2020 Corvette: Service Bulletin:: #20-NA-179: Malfunction Indicator Lamp (MIL) Illuminated - DTCs P0521 and/or P06DD Set - (Oct 23, 2020)

Subject: Malfunction Indicator Lamp (MIL) Illuminated – DTCs P0521 and/or P06DD Set

Brand:	Model:	Model Year:		VIN Breakpoint:		Engine:	Transmission:
		from	to	from	to		
Chevrolet	Corvette	2020	2020	SORP	September 10, 2020	6.2L (LT2)	—

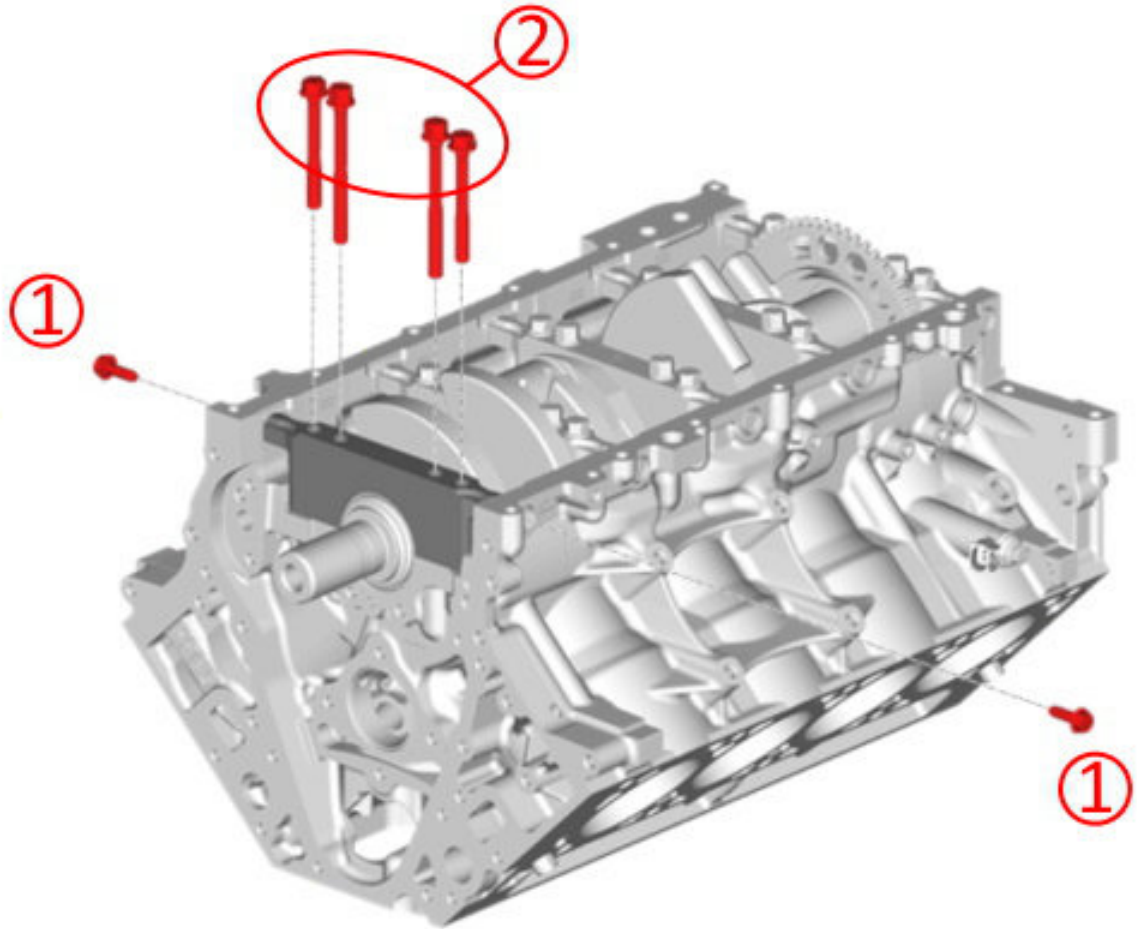
This condition may be caused by an unseated engine oil pressure control valve (OCV).

If P0521 and P06DD DTCs are present, then a redesigned oil pressure control valve retainer clip (1) may be necessary. Refer to the Service Procedure section below.

Note: If a vehicle comes in with one of these DTCs, follow SI for both DTCs to ensure there is not an electrical fault or other hardware concern. After diagnosis has been performed and no issues are found electrically, then it will be necessary to remove the engine oil pan and inspect for a unseated engine oil pressure control valve, which is mounted on the bottom of the engine oil pump.

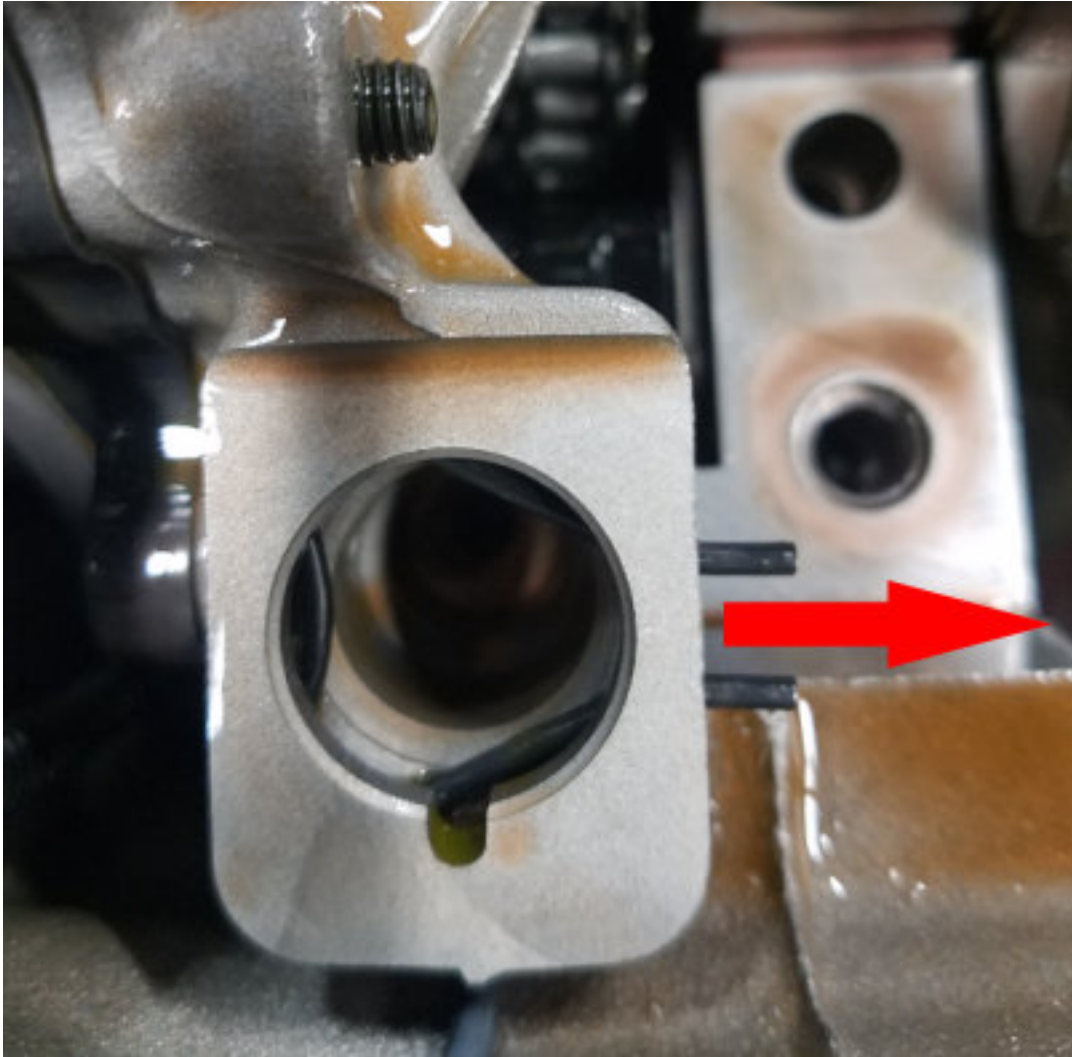
1. Inspect the OCV:
 - If you find this oil pressure control valve dislodged (1), it will be necessary to install a redesigned oil control valve retainer.
- Disconnect the oil pressure control valve electrical connector and position aside.

Note: Remove the existing oil pressure control valve retainer by pulling towards the rear and discard. You will be installing a newly designed retainer during installation.

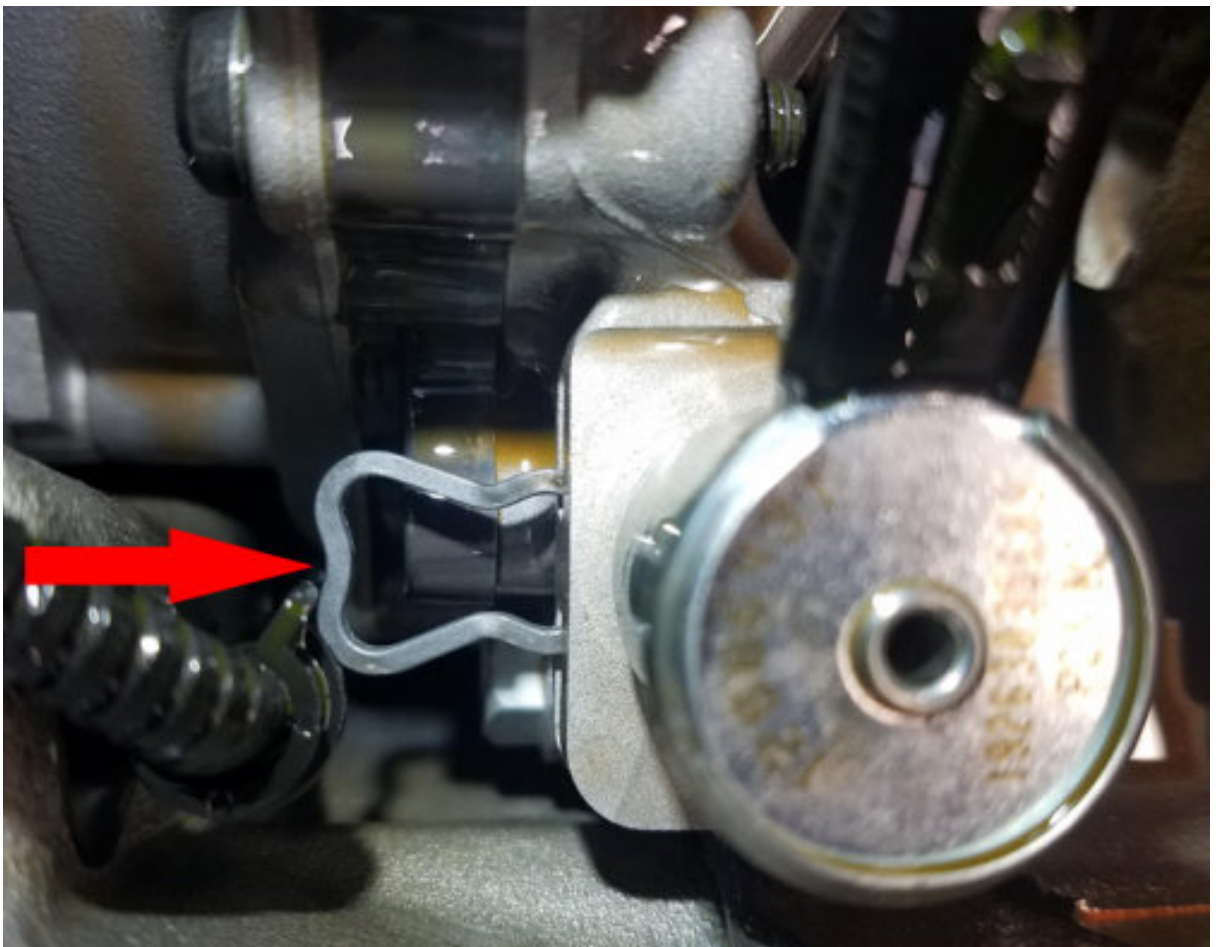
1. Push in the retainer and remove the oil pressure control valve and set aside.
2. Once the retainer is removed, inspect the oil pressure control valve for any signs of damage and ensure the O-ring is not cut.
 - Apply a small amount of clean engine oil to the pressure control valve and reinstall ensuring it is seated correctly.

Important: Do not use any tools to tap the pressure control valve into place. Only install the pressure control valve by pushing on the body of the valve by hand.

1. Install the new retainer from the front of engine towards the rear as shown in the graphic above.

1. When the retainer is installed, there should be about 2 to 3 mm of clearance between the retainer and the oil pump body as shown above.
